# 59th EVE IWG Session – Hybrid

January 10<sup>th</sup> 2023

UN HDV Battery Durability Open Points:  
OICA comments on JRC draft

# Annex 3 Test procedure and determination of performance parameters

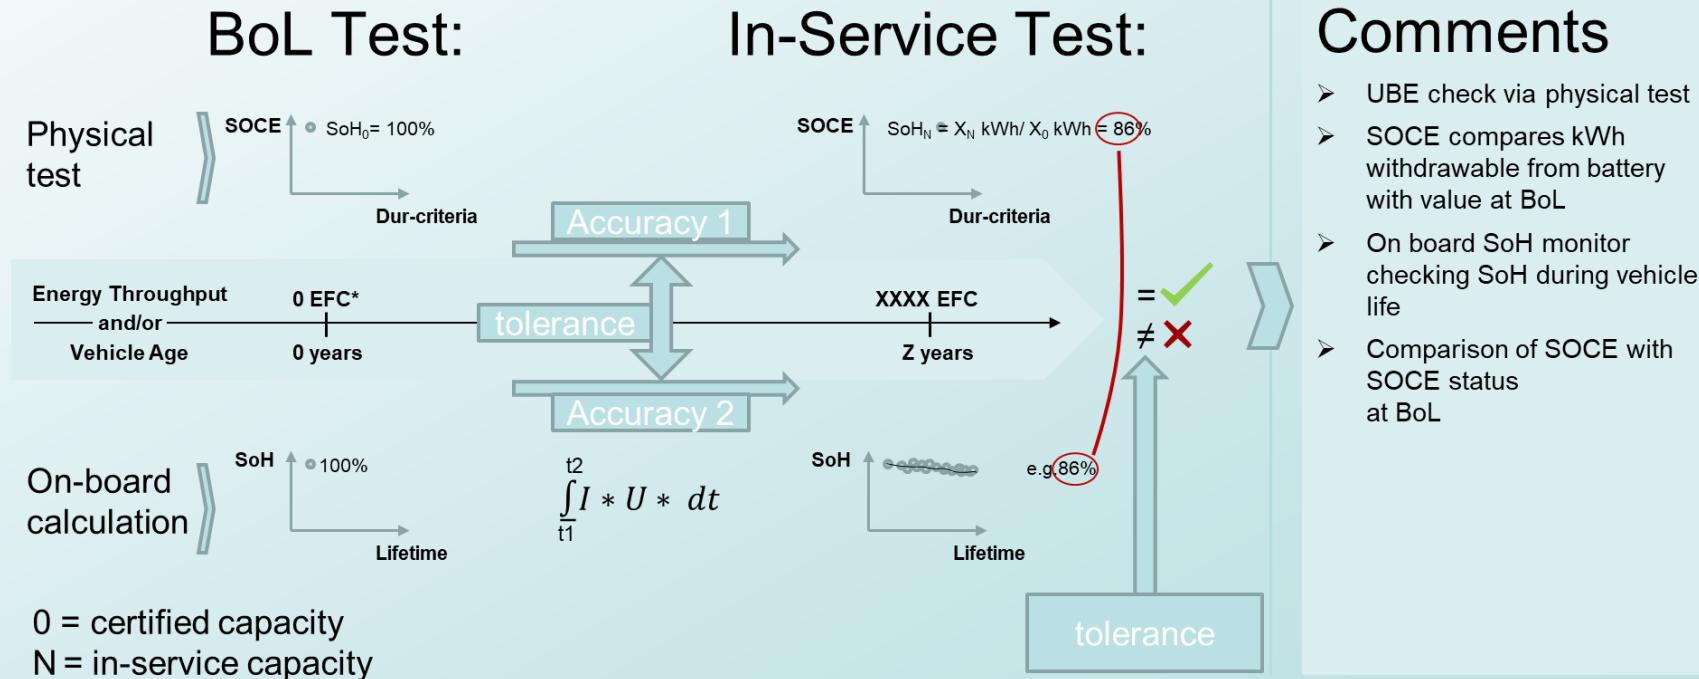
Most time consuming for drafting group.  
 Parallel elaboration at OEMs facilities  
 necessary / helpful.
